**SAN ANTONIO WATER SYSTEM
CENTRAL WATER INTEGRATION PIPELINE
SEGMENT 5-1
SAWS Job No. 18-8612
SAWS Solicitation No. CO-00181**

**ADDENDUM No. 6
August 9, 2018**

L-102

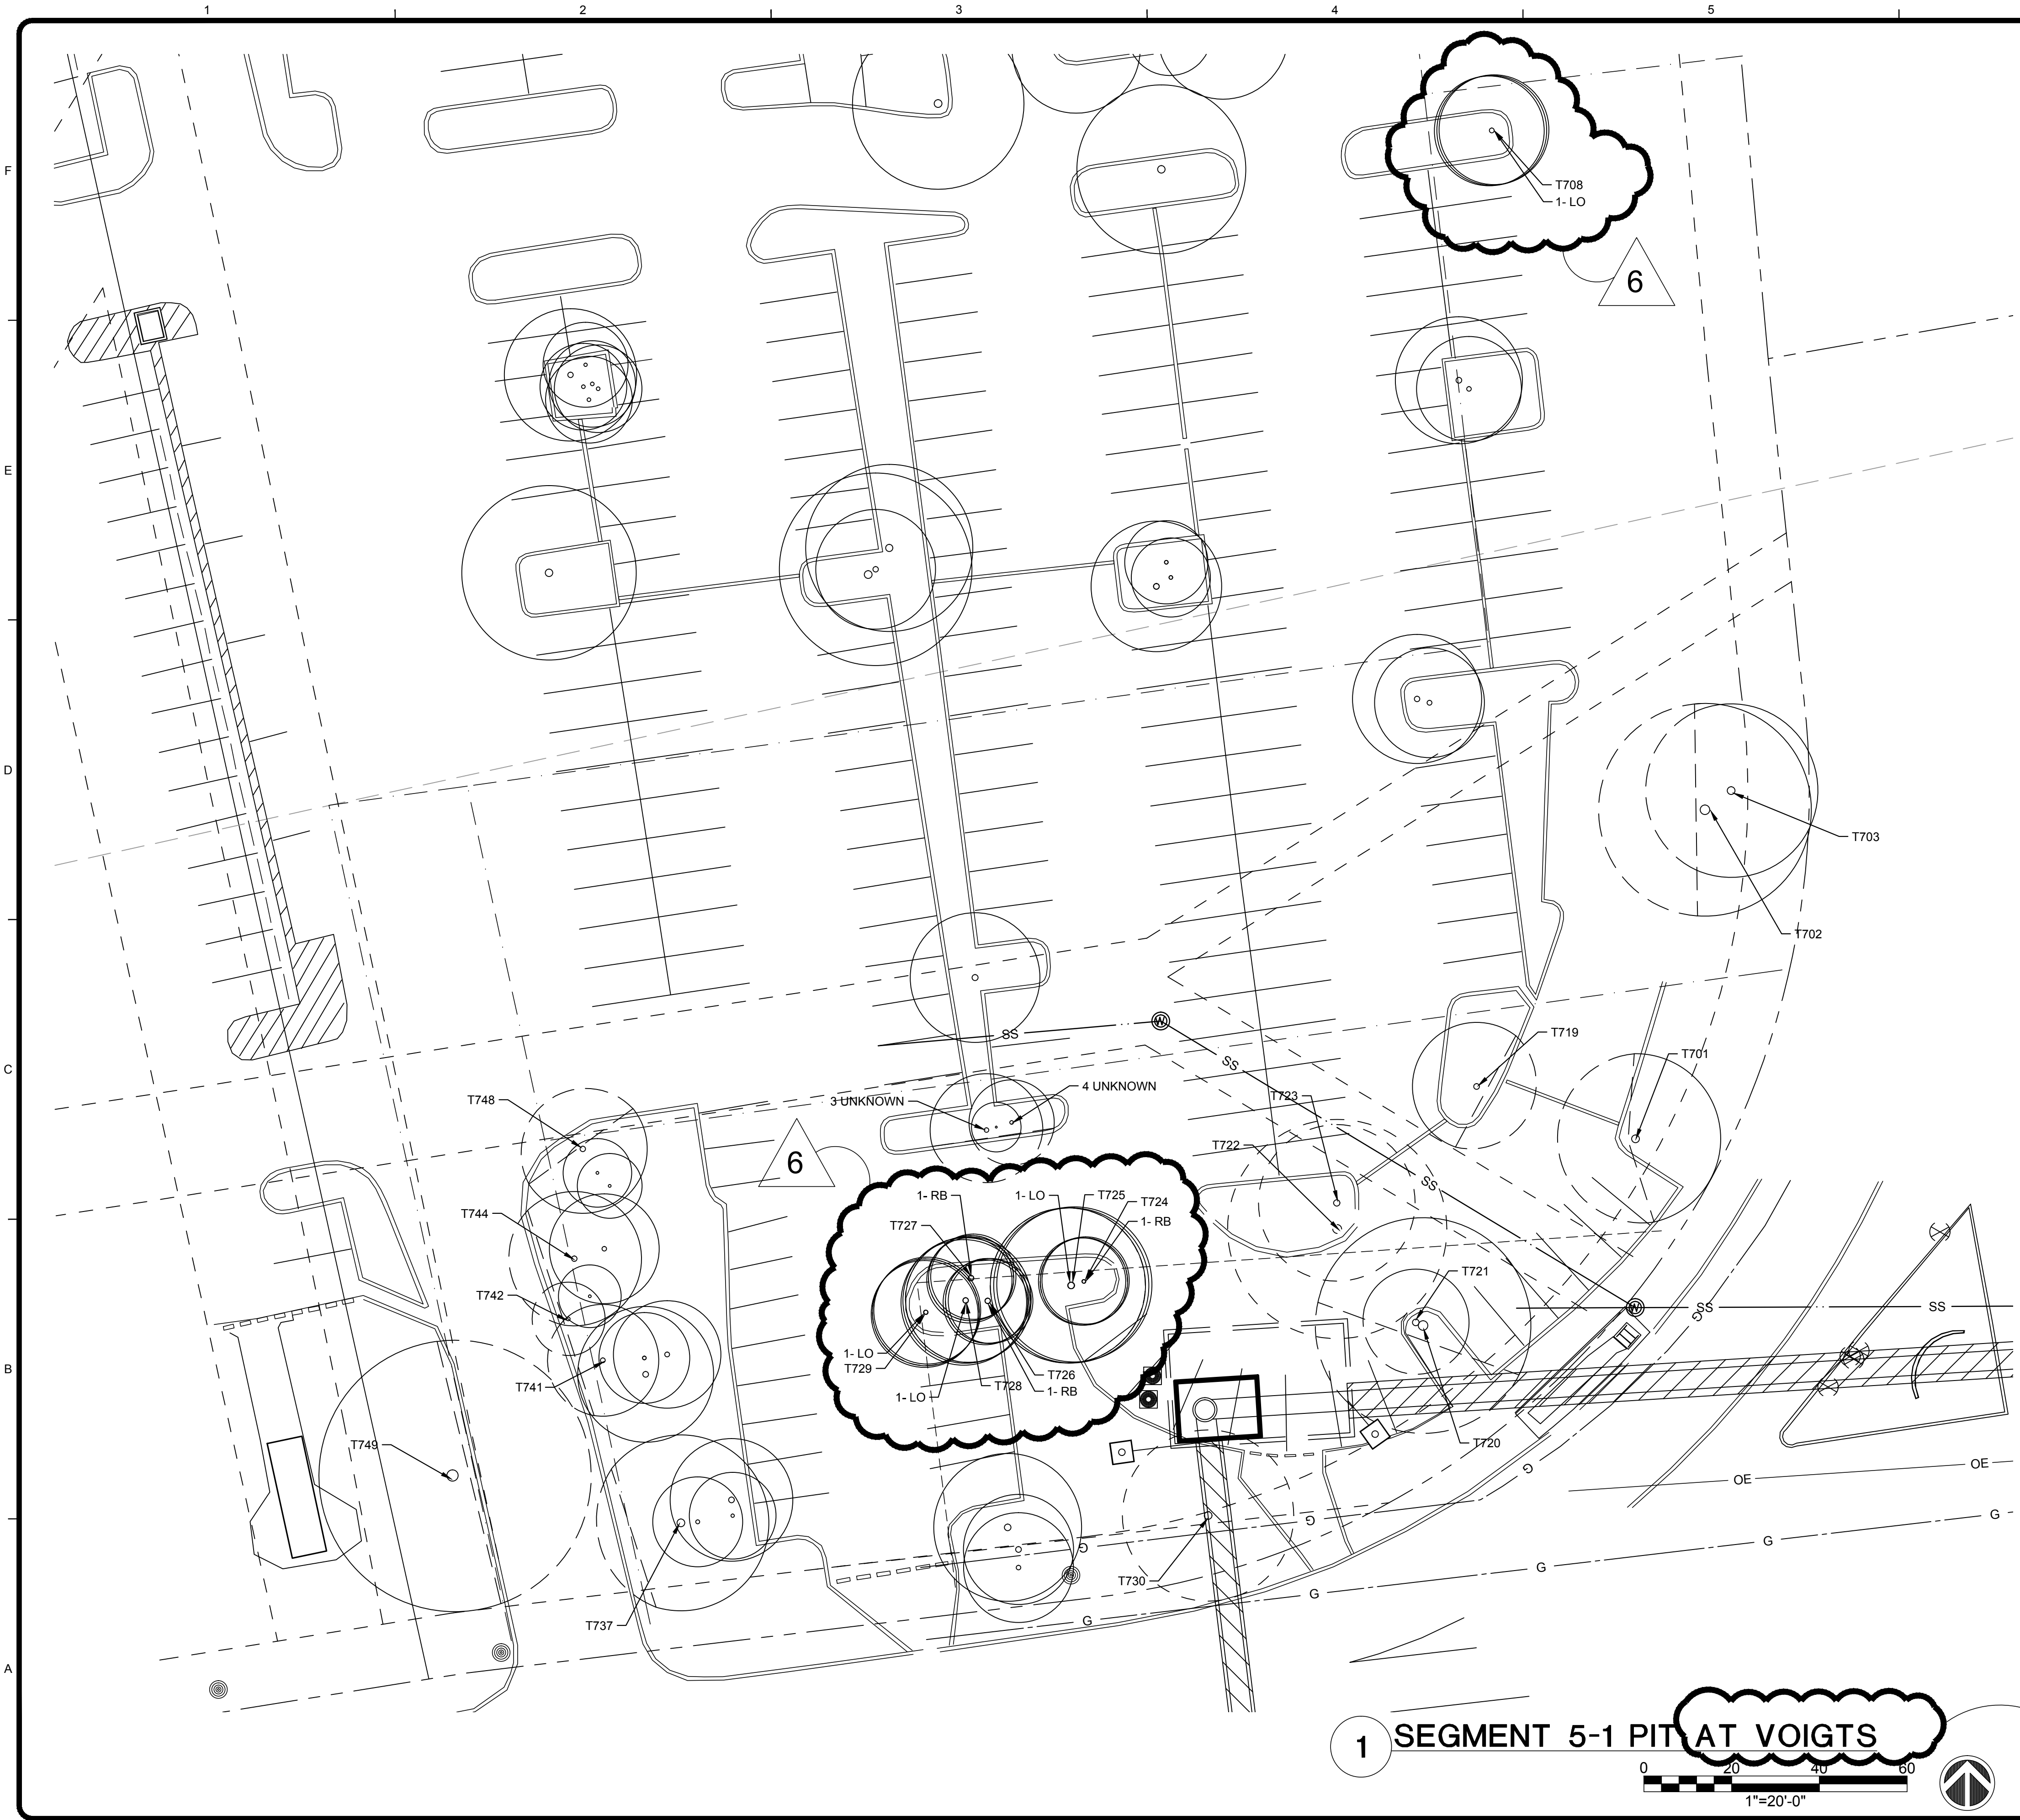
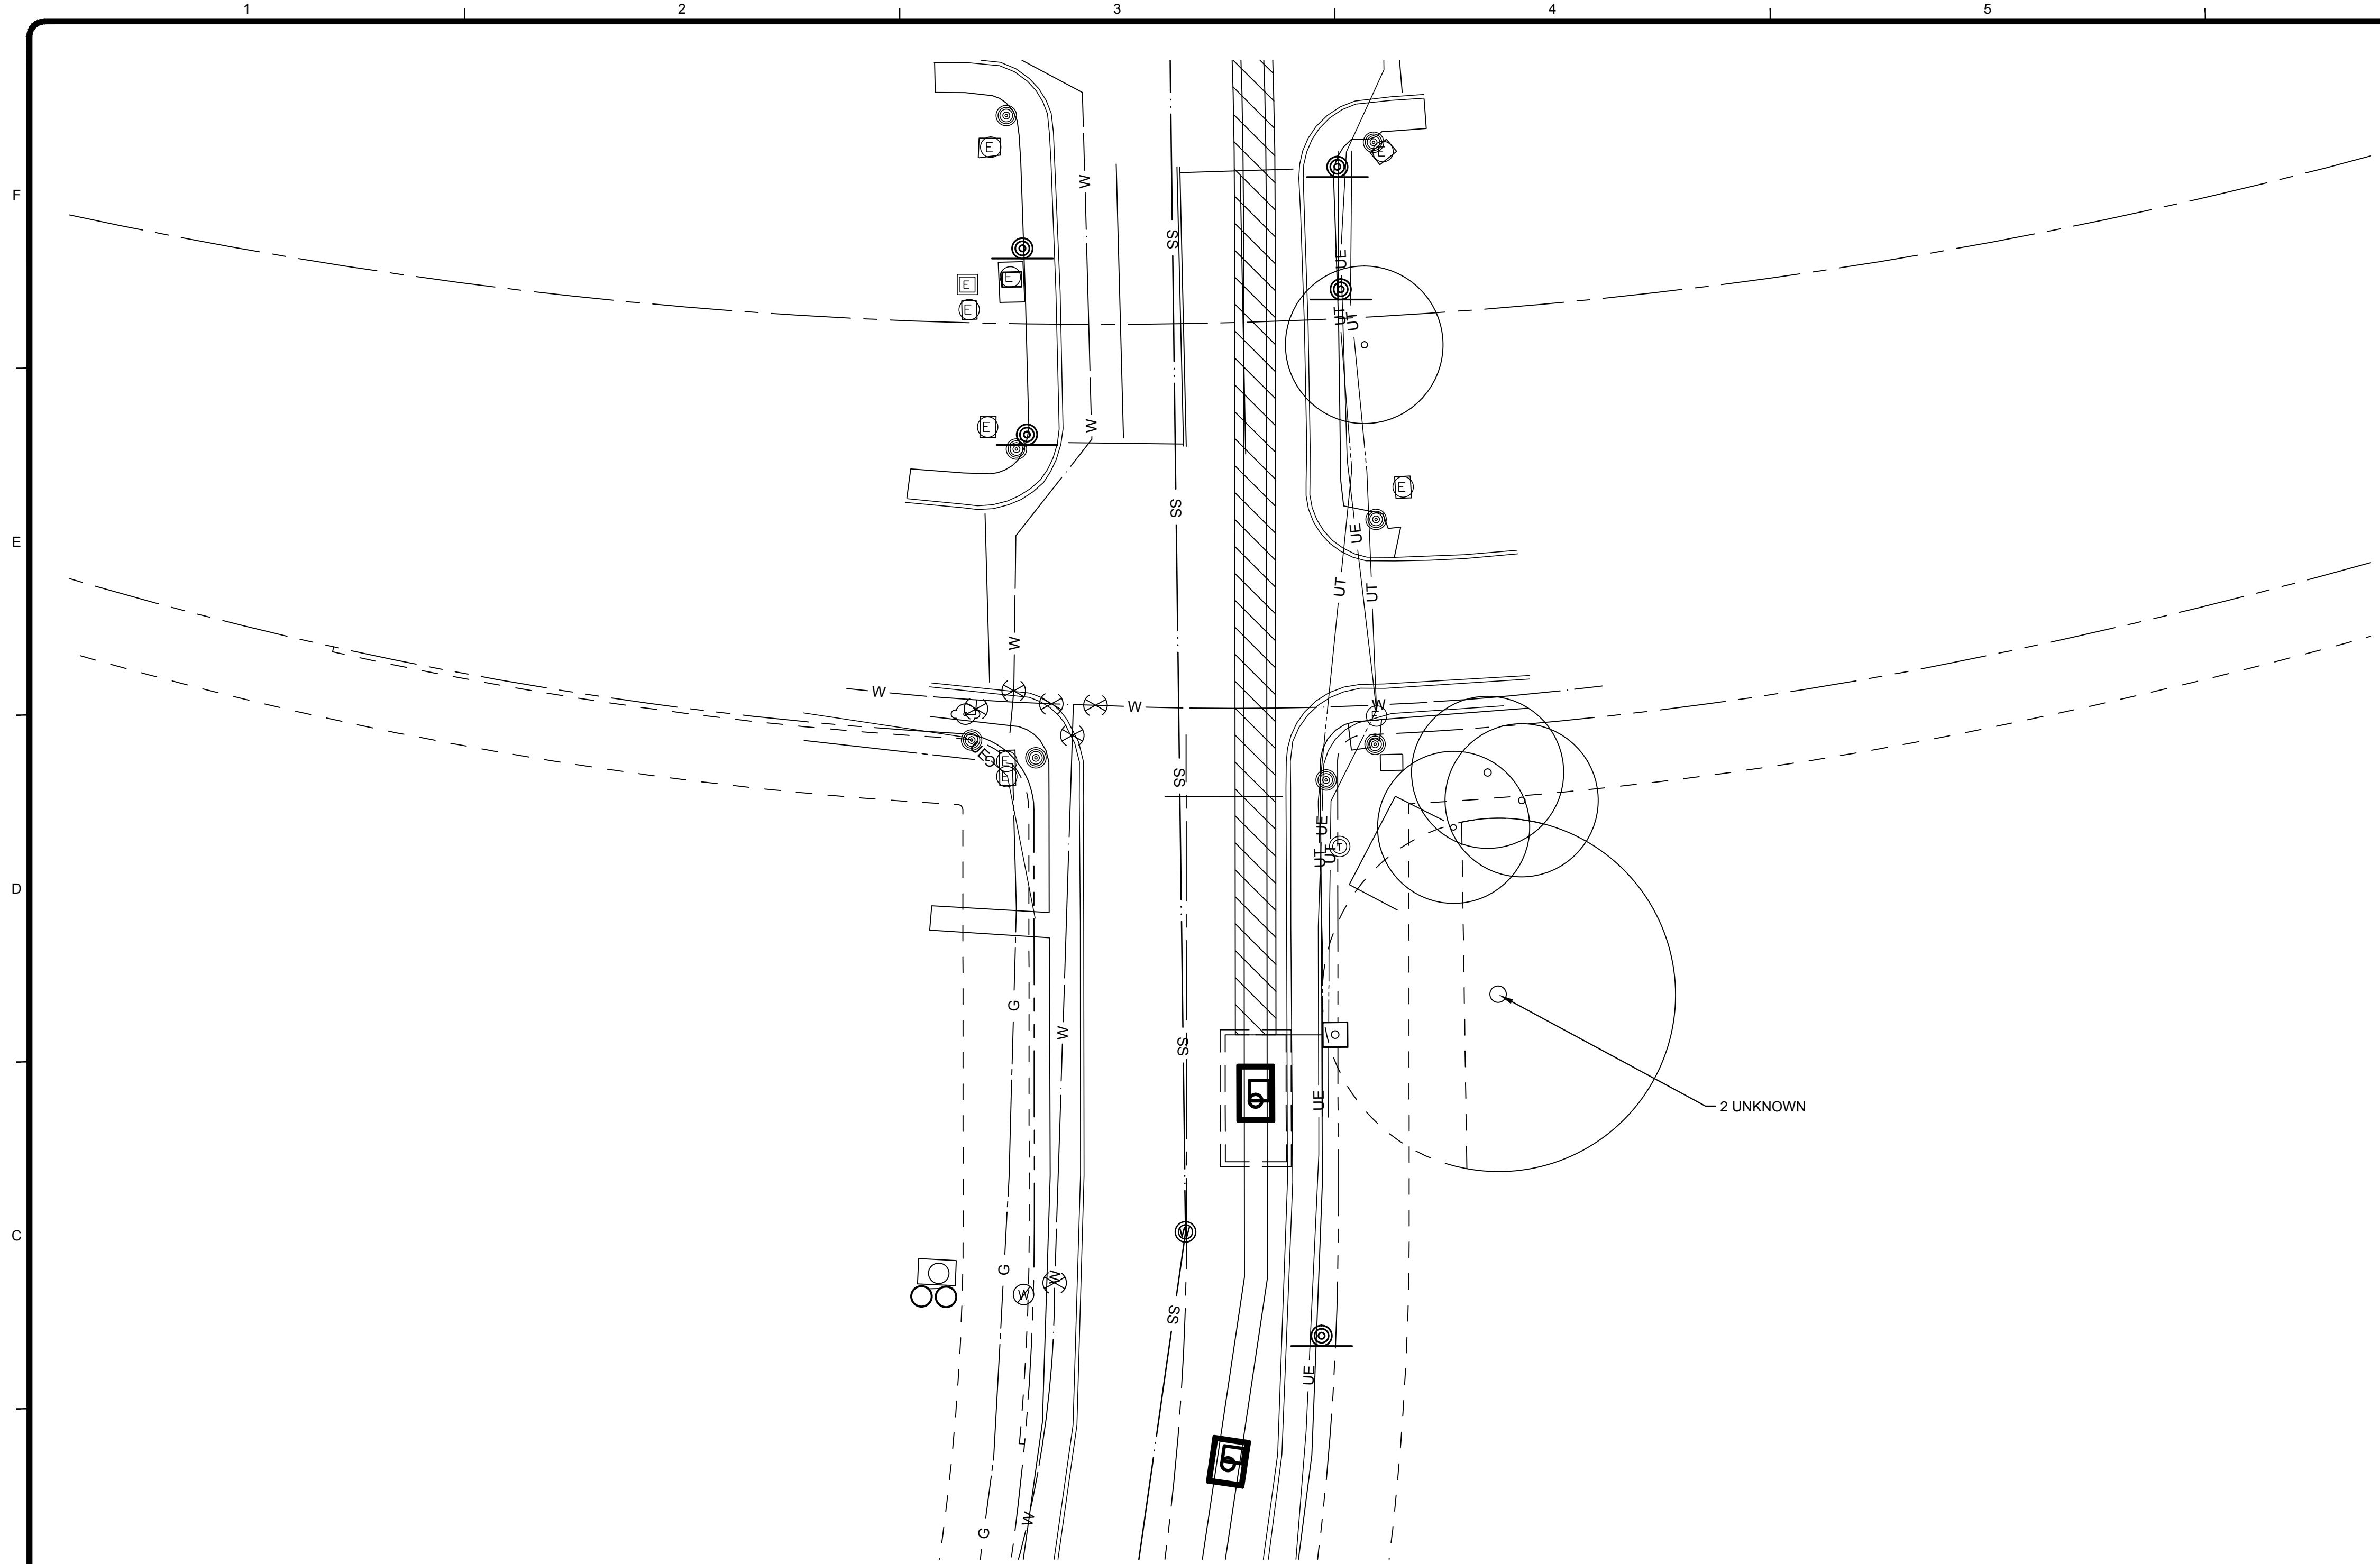
SHEET L-102 – TREE PLAN

- a) Delete Sheet L-102 in its entirety and replace with the revised version included in this Addendum titled “TREE PRESERVATION PLANS”

L-103

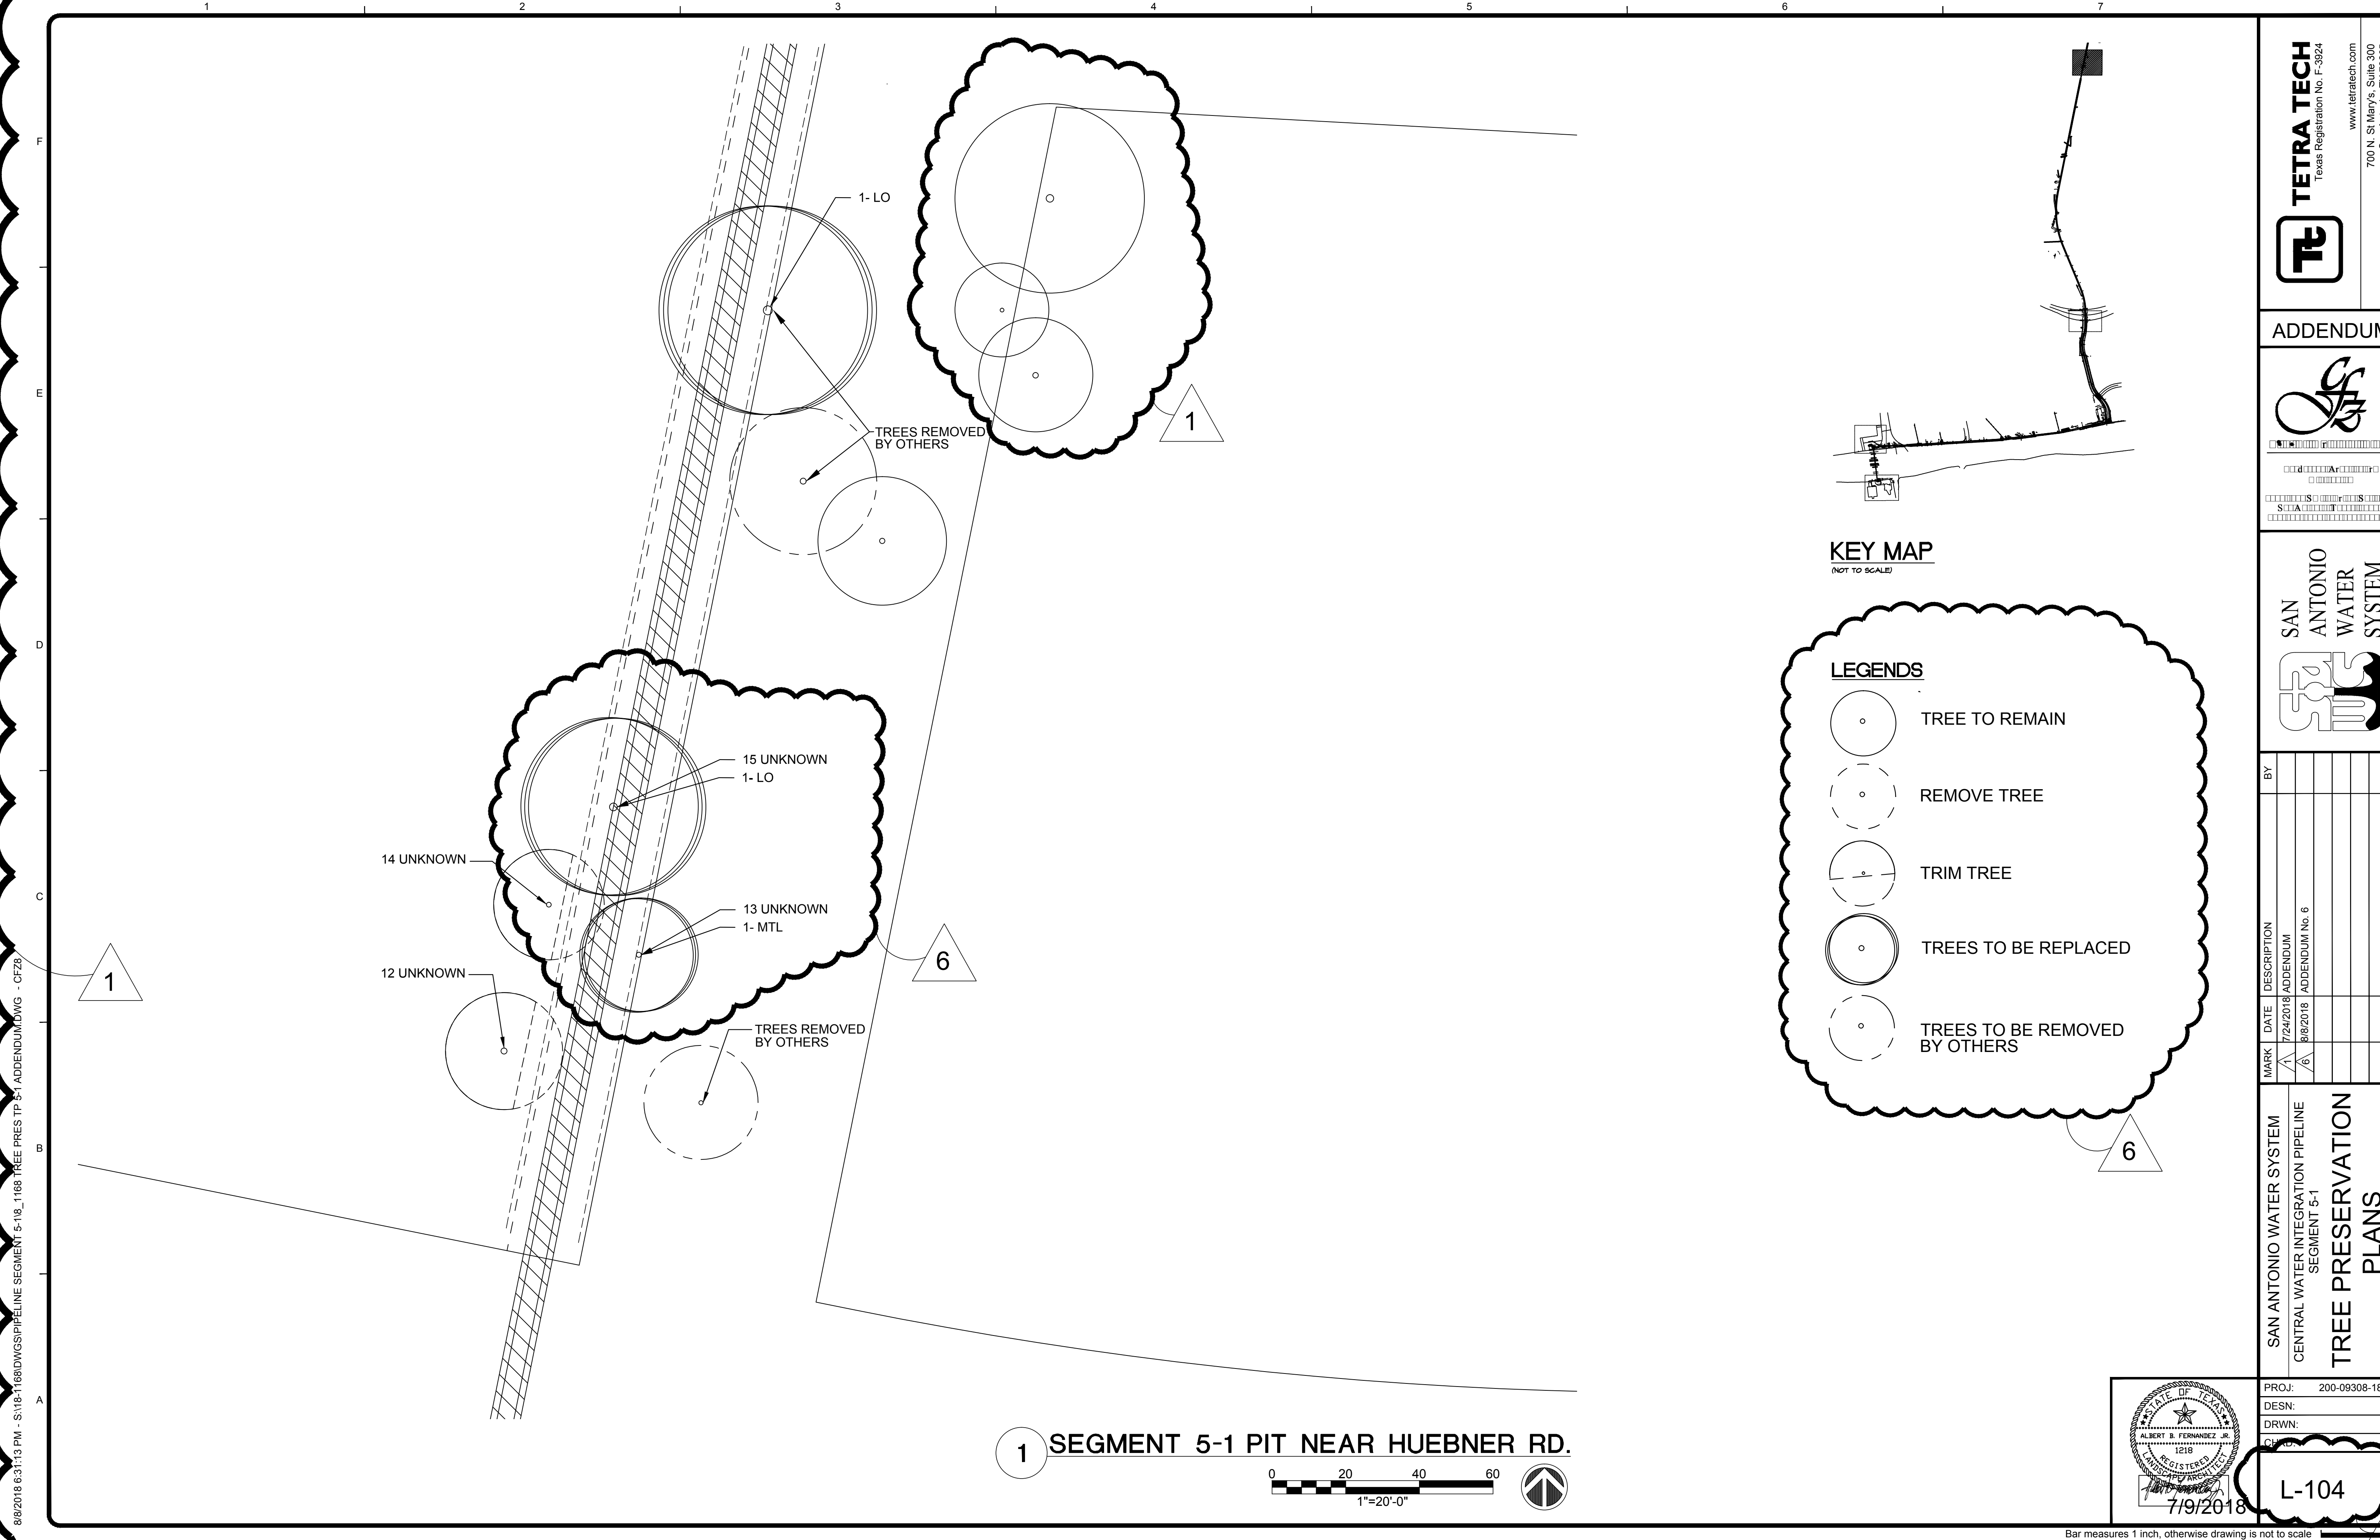
SHEET L-103 – TREE PLAN

- a) Delete Sheet L-103 in its entirety and replace with the revised version included in this Addendum titled “TREE PRESERVATION PLANS”
